SAN ANTONIO WATER SYSTEM
Dos Rios Water Recycling Center (DRWRC) Digester Mixing and System
Enhancements, Phase II
SAWS Job No. 11-6502
Solicitation No. B-12-053-MF

ADDENDUM NO. 4

EXHIBIT NO. 001201-A

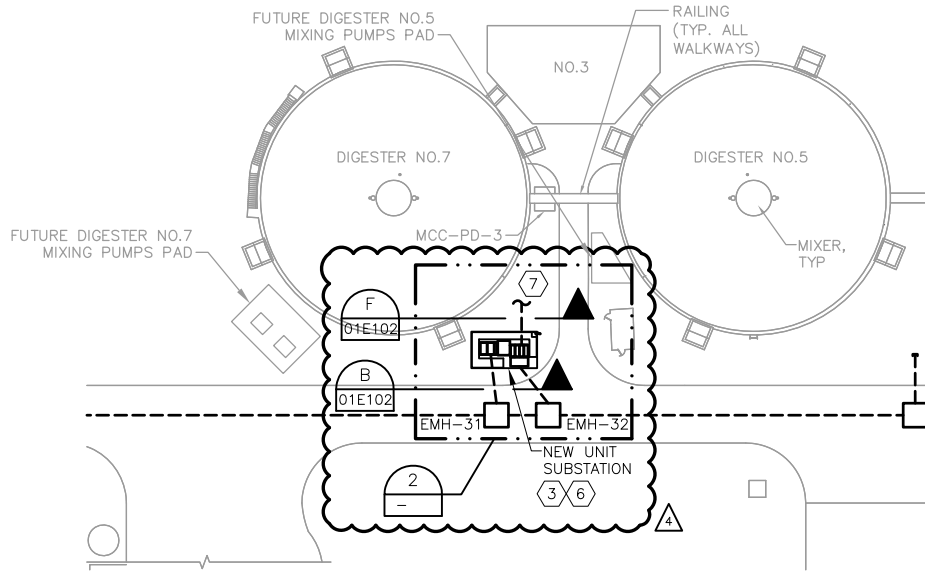
1. Drawing No. 00I201
 - a. For modifications to this drawing, refer to attached Exhibit 00I201-A.
2. Drawing No. 01E101
 - a. For modifications to this drawing, refer to attached Exhibit 01E101-A.
3. Drawing No. 01E102
 - a. Add Section I to this drawing, refer to attached Exhibit 01E102-A.
4. Drawing No. 03E102
 - a. For modifications to this drawing, refer to attached Exhibit 03E102-A.
5. Drawing No. 03E103
 - a. For modifications to this drawing, refer to attached Exhibit 03E103-A.
6. Drawing No. 03E107

SAWS JOB NO. 11-6502	
DRWRC-DIGESTER MIXING AND SYSTEM ENHANCEMENTS - PHASE II	
ADDENDUM NO. 4	
DATE: 11-14-2012	
DWG. NO. 03E109	EXHIBIT NO. 03E109-A

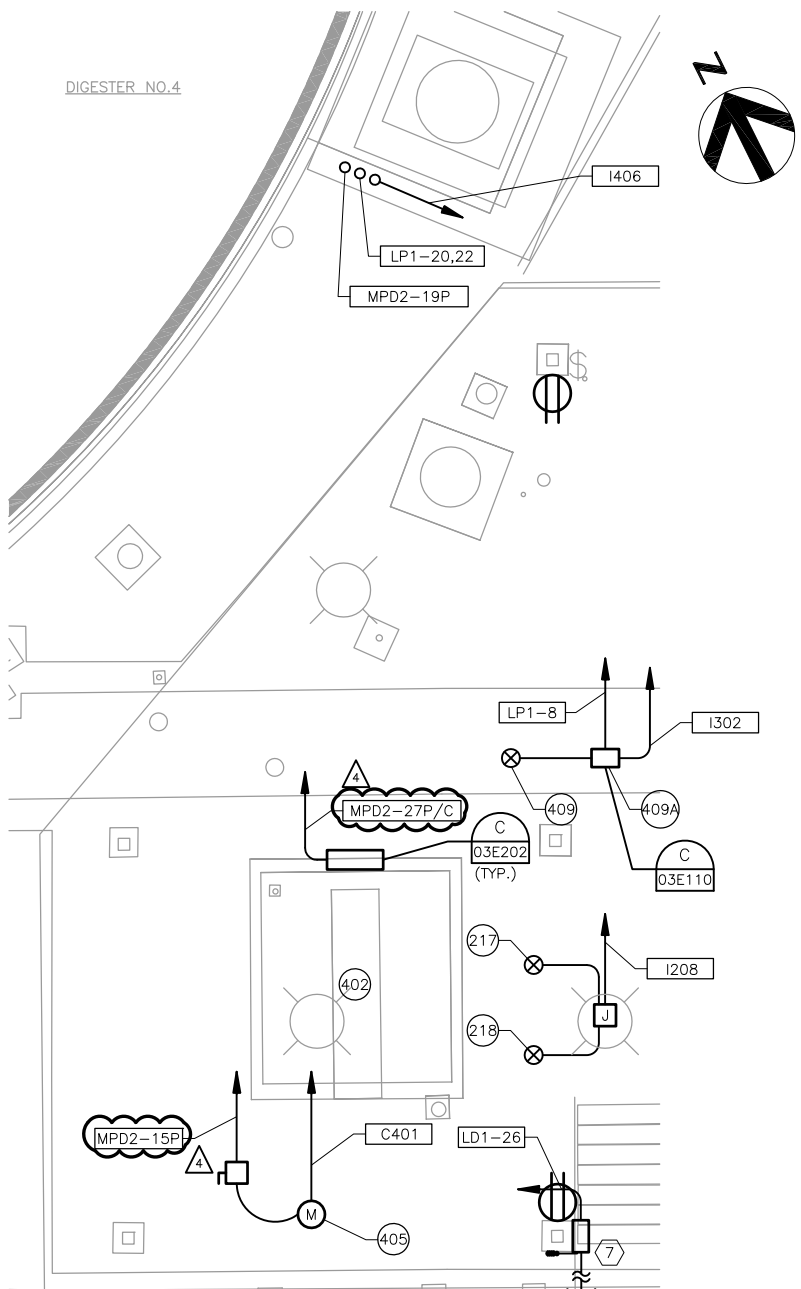
8. Drawing No. 03E109
 - a. For modifications to this drawing, refer to attached Exhibit 03E109-A.
9. Drawing No. 03E109
 - a. For modifications to this drawing, refer to attached Exhibit 03E109-B.

EXHIBIT NO. 03E111-A

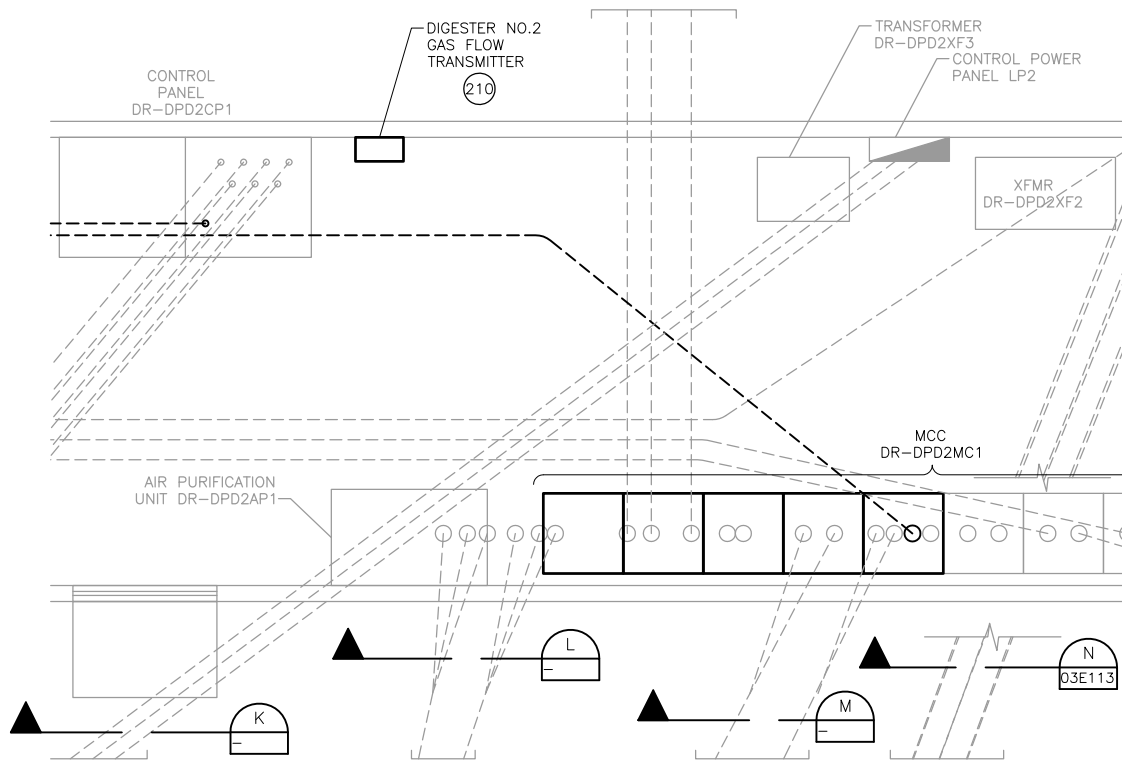
10. Drawing No. 03E111
 - a. For modifications to this drawing, refer to attached Exhibit 03E111-A.
11. Drawing No. 03E112
 - a. For modifications to this drawing, refer to attached Exhibit 03E112-A.

EXHIBIT NO. 03E302-A

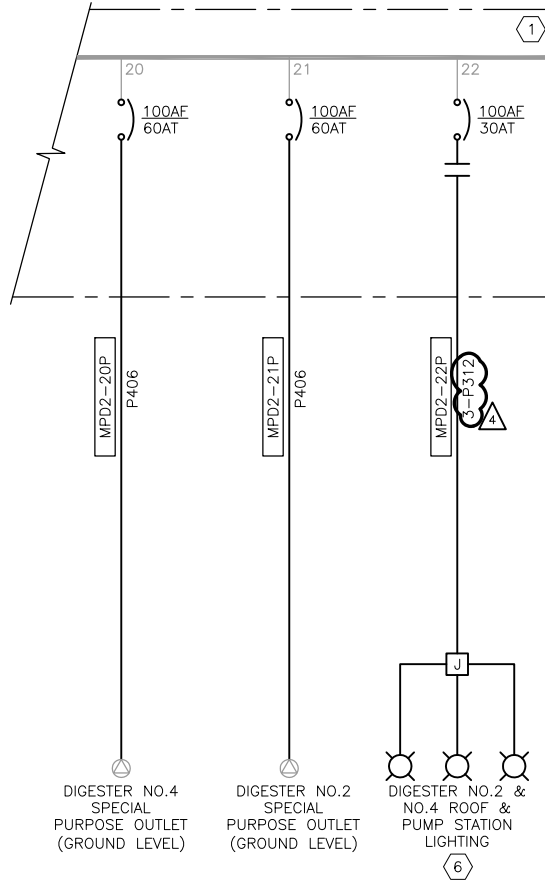
12. Drawing No. 03E112
 - a. For modifications to this drawing, refer to attached Exhibit 03E112-B.
13. Drawing No. 03E302
 - a. For modifications to this drawing, refer to attached Exhibit 03E302-A.

EXHIBIT NO. 03E305-A

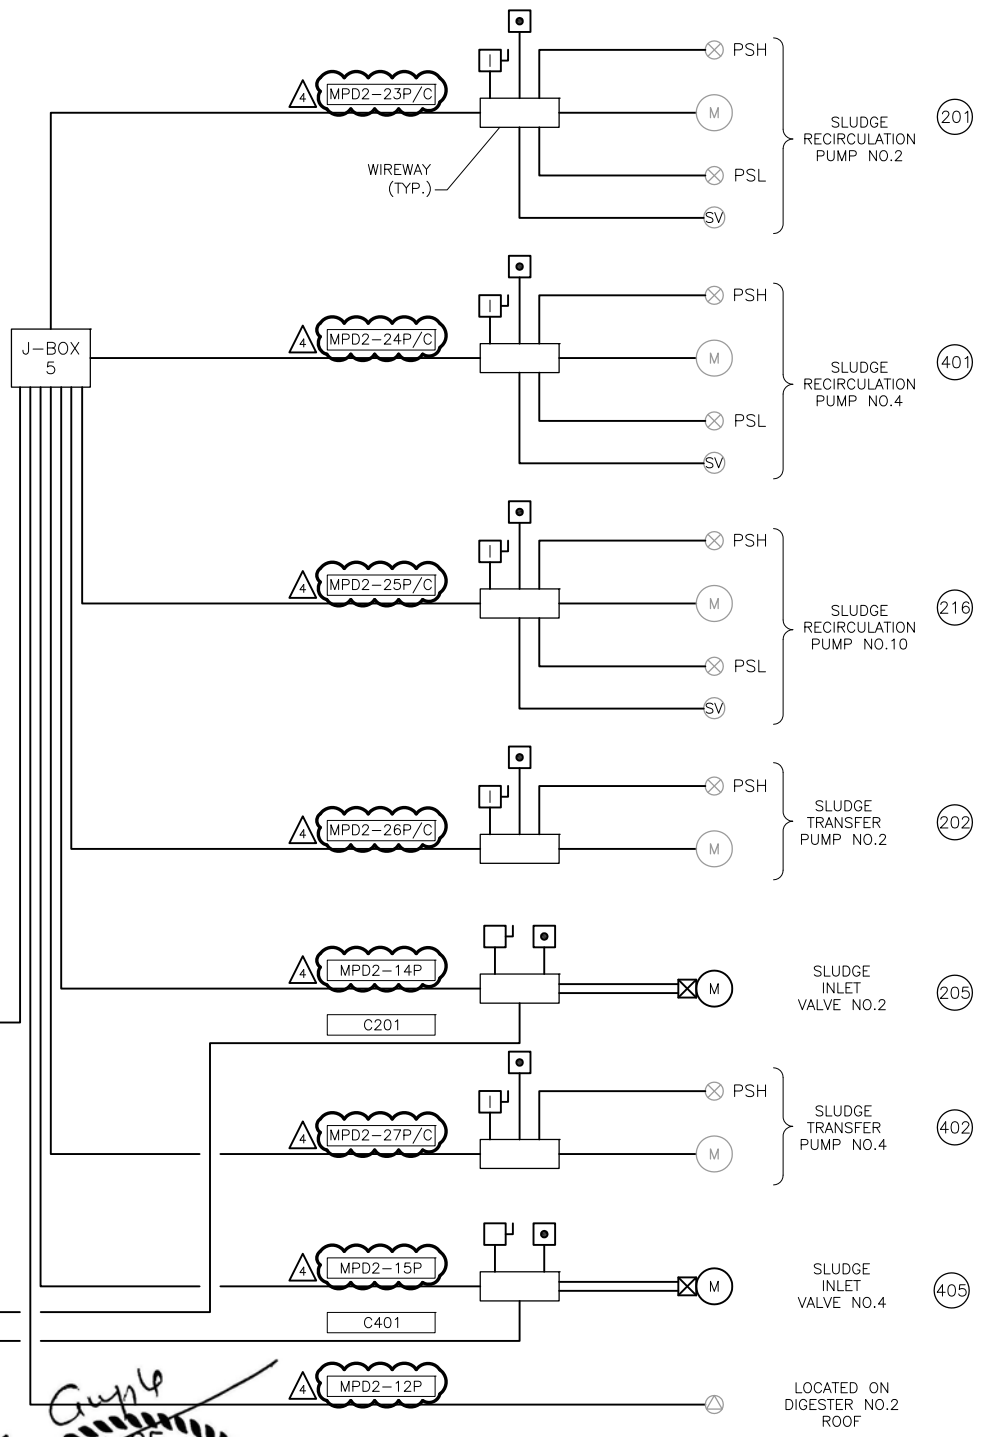
14. Drawing No. 03E304
 - a. For modifications to this drawing, refer to attached Exhibit 03E304-A.
15. Drawing No. 03E305
 - a. For modifications to this drawing, refer to attached Exhibit 03E305-A.

SAWS JOB NO. 11-6502	
DRWRC-DIGESTER MIXING AND SYSTEM ENHANCEMENTS - PHASE II	
ADDENDUM NO. 4	
DATE: 11-14-2012	
DWG. NO. 03E311	EXHIBIT NO. 03E311-A

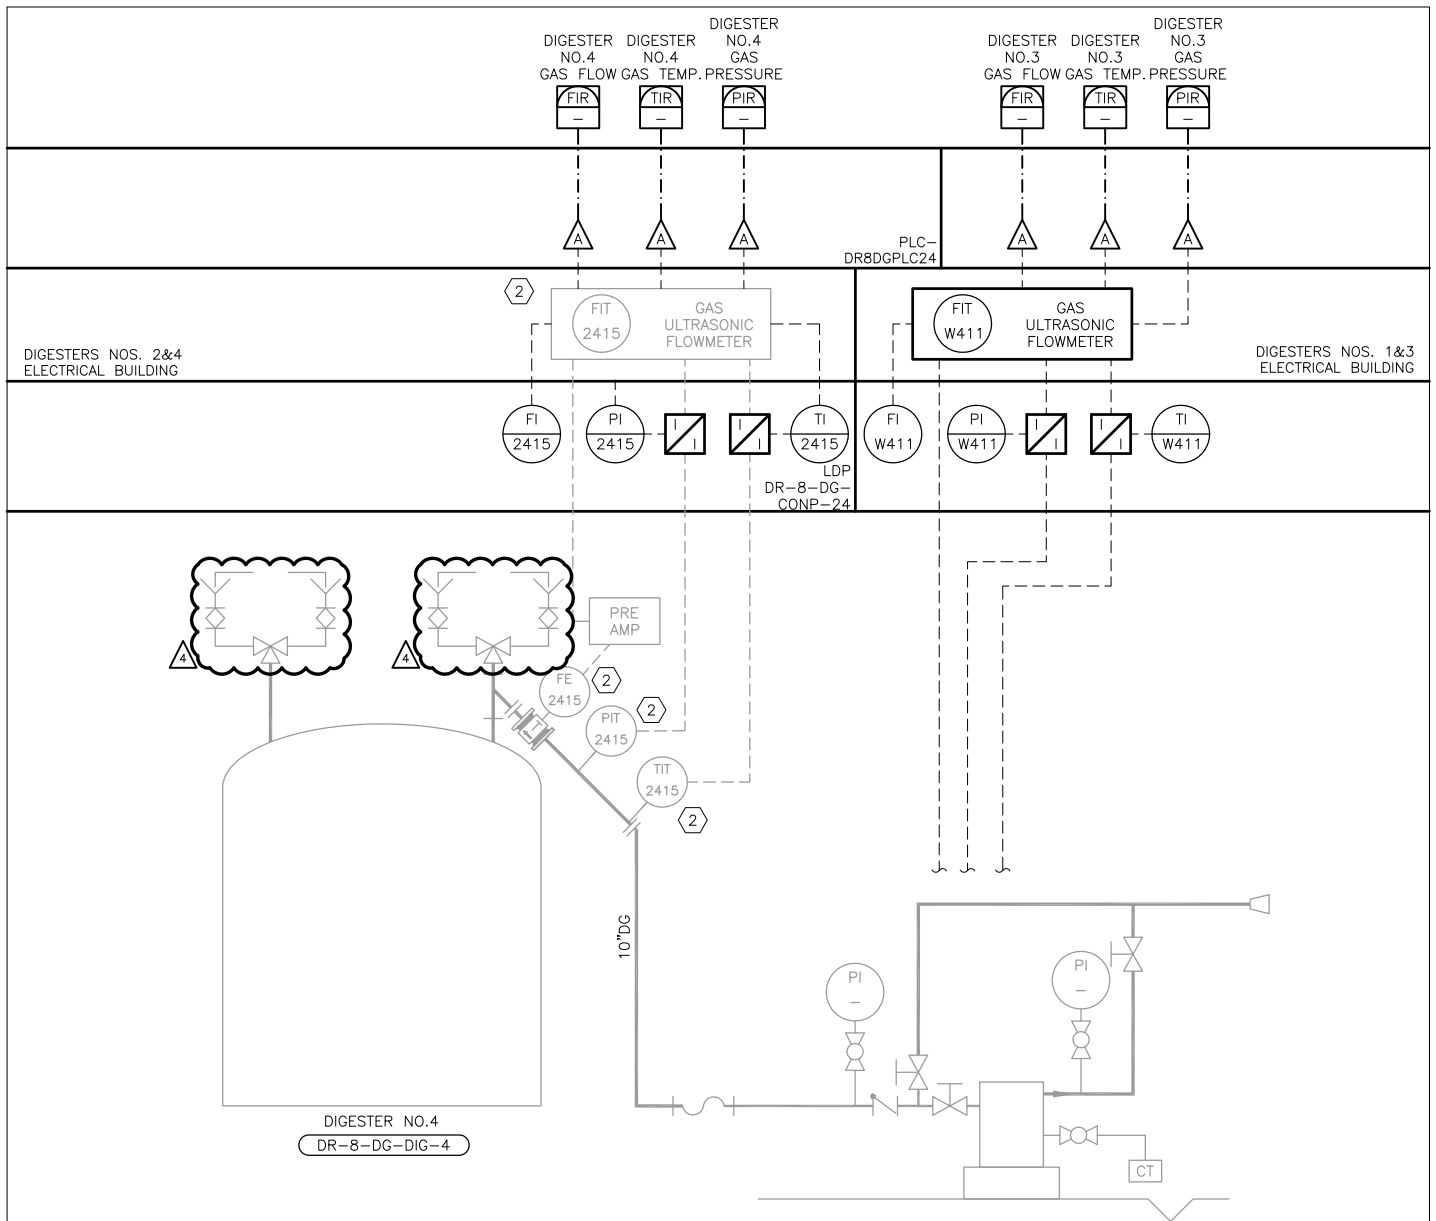
16. Drawing No. 03E306
 - a. For modifications to this drawing, refer to attached Exhibit 03E306-A.
17. Drawing No. 03E311
 - a. For modifications to this drawing, refer to attached Exhibit 03E311-A.

<p>SAN ANTONIO WATER SYSTEM</p>	 HDR Engineering, Inc. <small>Texas P.E. Firm Registration No. F-754</small>	SAWS JOB NO. 11-6502	
		DRWRC - DIGESTER MIXING AND SYSTEM ENHANCEMENTS - PHASE II	
		ADDENDUM NO. 4	
		DATE NOVEMBER 19, 2012	
		DWG. NO. 03S103	EXHIBIT NO. 03S103-A

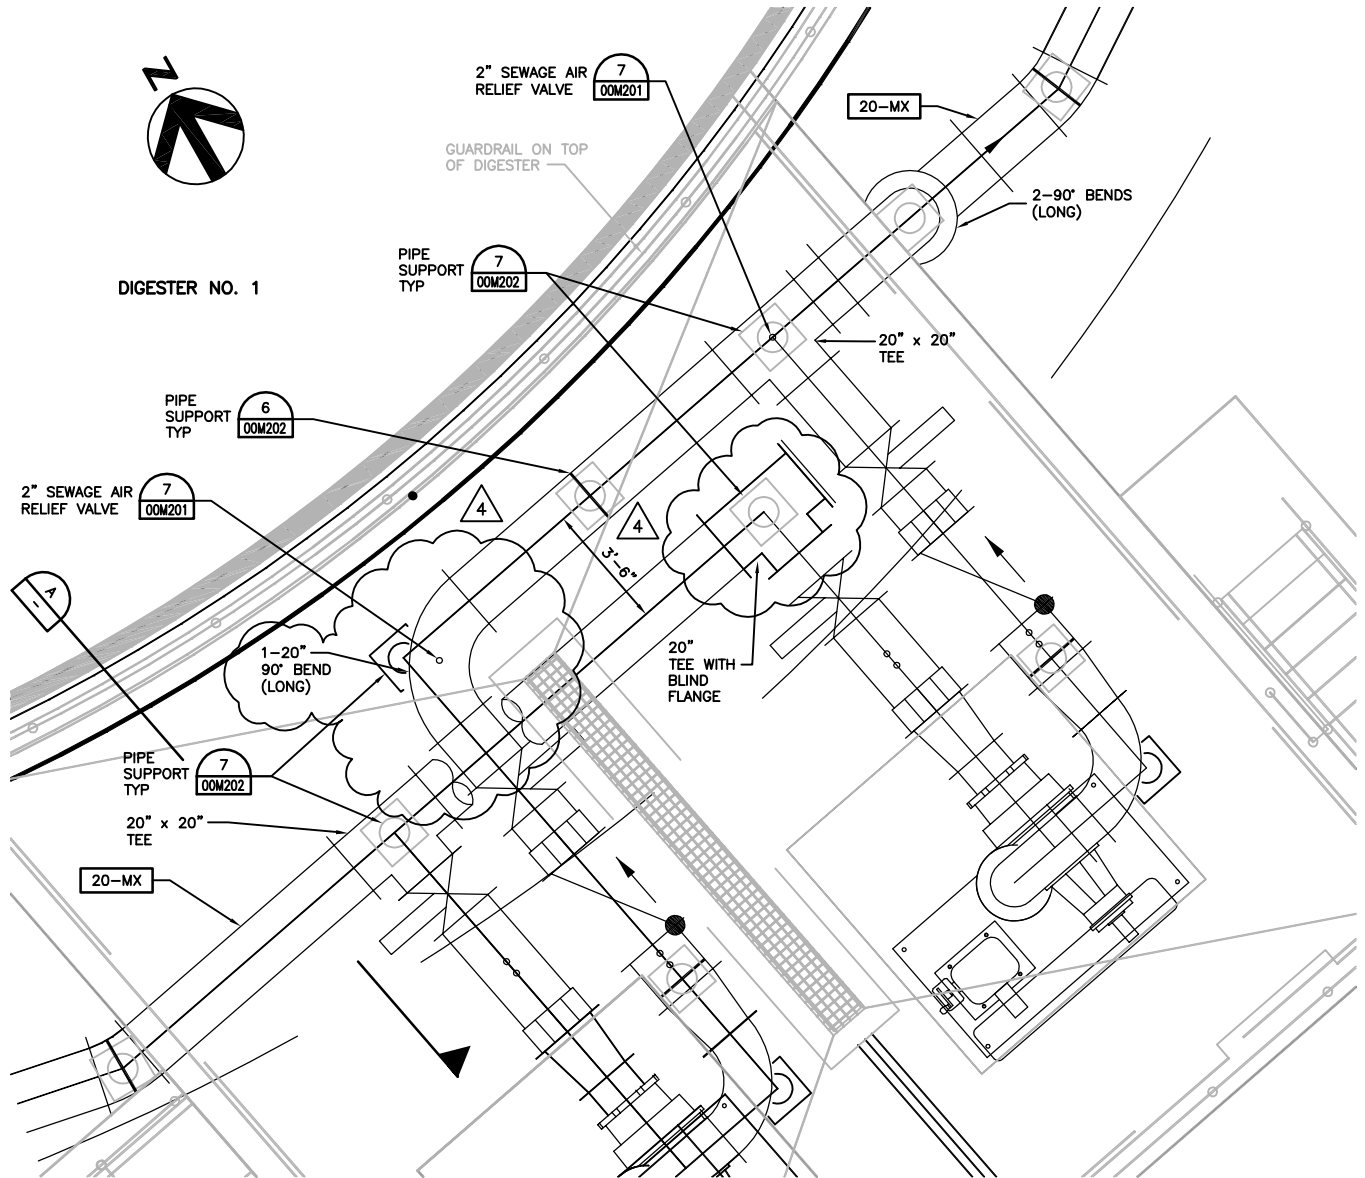
20. Drawing No. 03S103
 - a. For modifications to this drawing, refer to attached Exhibit 03S103-A.
21. Drawing No. 03M202
 - a. For modifications to this drawing, refer to attached Exhibit 03M202-A.

EXHIBIT NO. 03M202-B

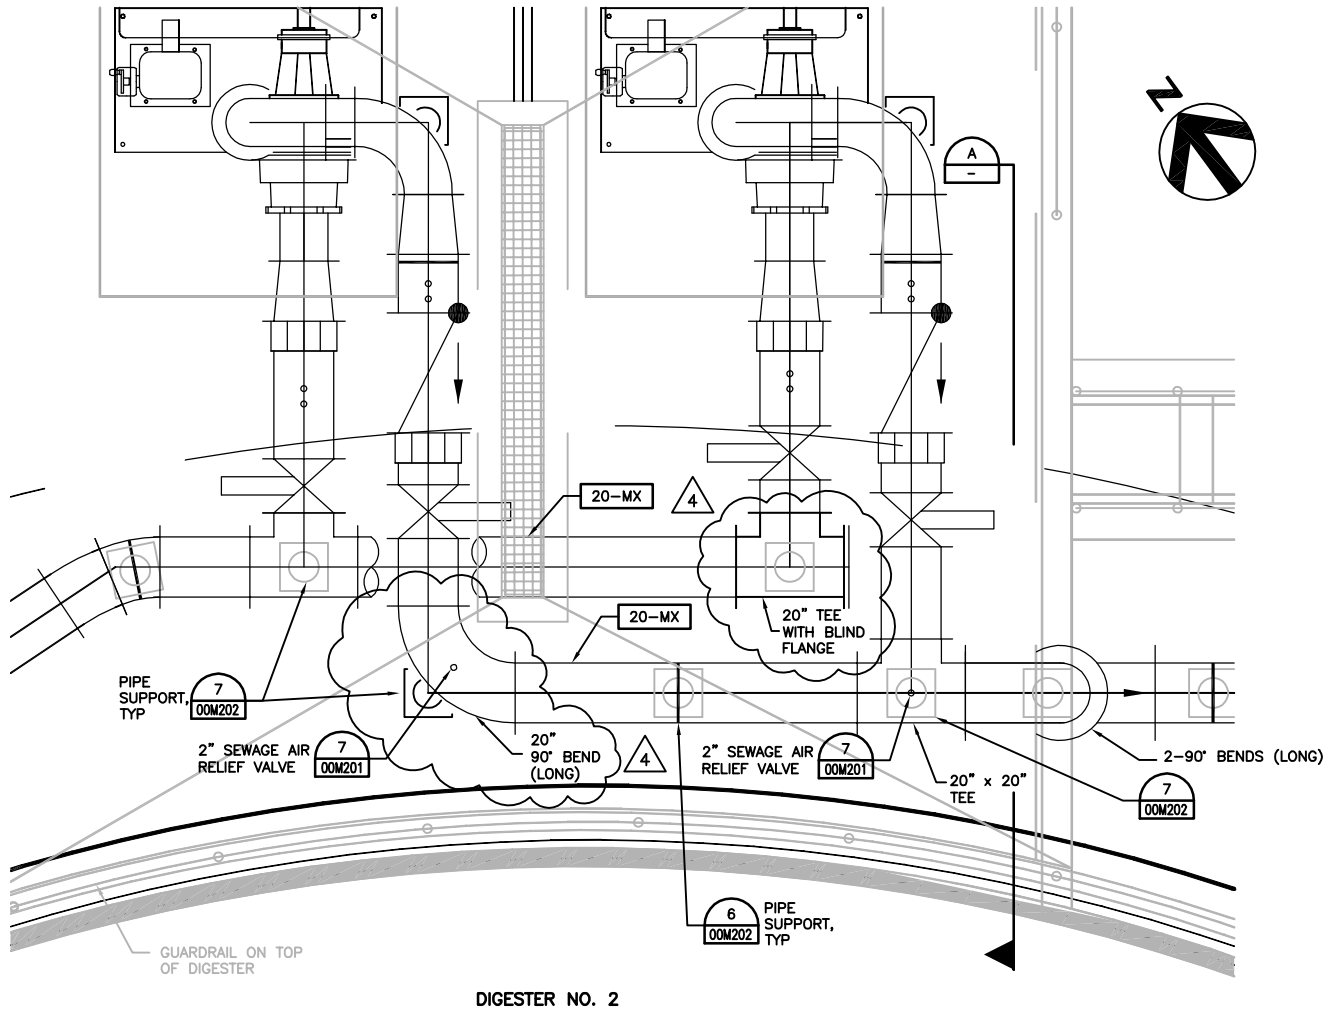
22. Drawing No. 03M202
 - a. For modifications to this drawing, refer to attached Exhibit 03M202-B.
23. Drawing No. 03M203
 - a. For modifications to this drawing, refer to attached Exhibit 03M203-A.

EXHIBIT NO. 03M203-A

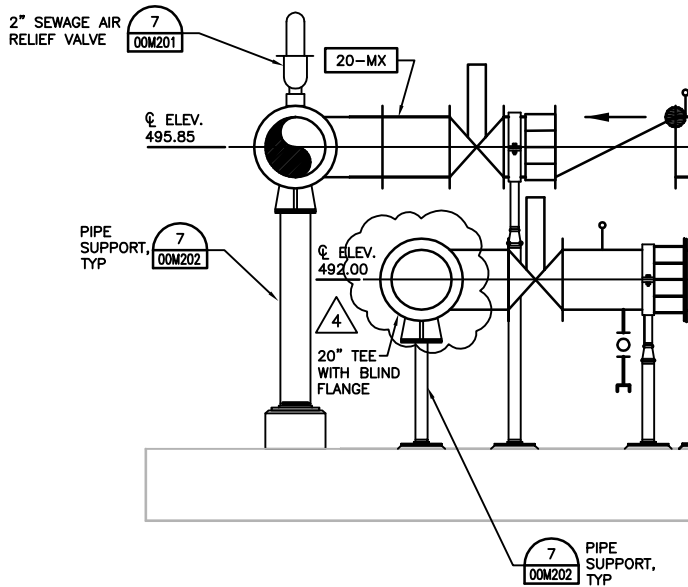
24. Drawing No. 03M203
 - a. For modifications to this drawing, refer to attached Exhibit 03M203-B.
25. Drawing No. 03M204
 - a. For modifications to this drawing, refer to attached Exhibit 03M204-A.
